SUBJECT

Recall Campaign 12V-161: Replace the Auxiliary Coolant Pump for Turbocharger

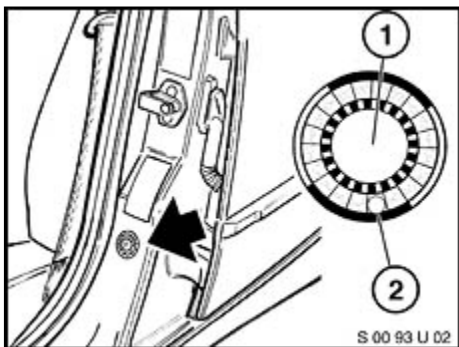
An internal crack in the housing of the auxiliary coolant pump may cause coolant to leak into the electronics of the pump, which could cause a short circuit. This short circuit may cause the auxiliary water pump to overheat. In rare cases where overheating occurs, a fire in the engine compartment or in the entire vehicle is possible.

Replace the auxiliary water pump for the turbochargers with an improved pump (refer to parts information). Refer to Repair Instruction RA 11 53 000 (5, 6 and 7 Series) or RA 11 53 090 (X5 and X6) for replacement of the pump and proper coolant bleeding procedures.

Note: This repair procedure involves draining a small quantity of coolant; replenish the drained quantity with new BMW long-term antifreeze/coolant (50/50 mixture). Do not reuse the drained coolant.
